# Technical Service Bulletin

**Cobra Moto, LLC**

## TSB0219 2018 CX65 Swingarms

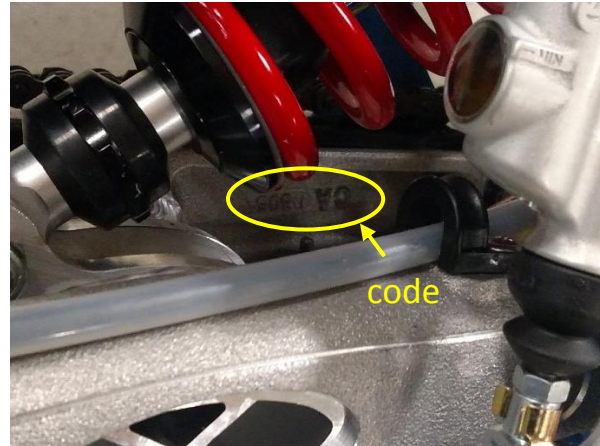
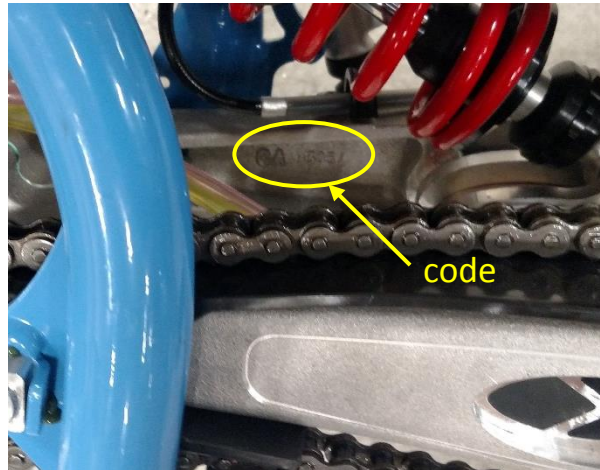
Swingarms produced with casting code CA292 or CA305 are prone to failure. Swingarms with any other casting code including CA087 or any code of 4 digits followed by a letter (like 4132A) are okay to continue using.

To look for casting codes, one should look inside the swingarm side arms behind the swingarm pivot and in front of the shock mount. The codes on the swingarms shown below are CA305 and CA292.

The pictures below show the where the casting codes can be seen on the motorcycle.

It is recommended that these motorcycles not be ridden until which time Cobra can provide customers updated replacements swingarms. We are scheduling these to start shipping in late September 2018. Please call Cobra Customer Service and have your VIN along with swingarm code.
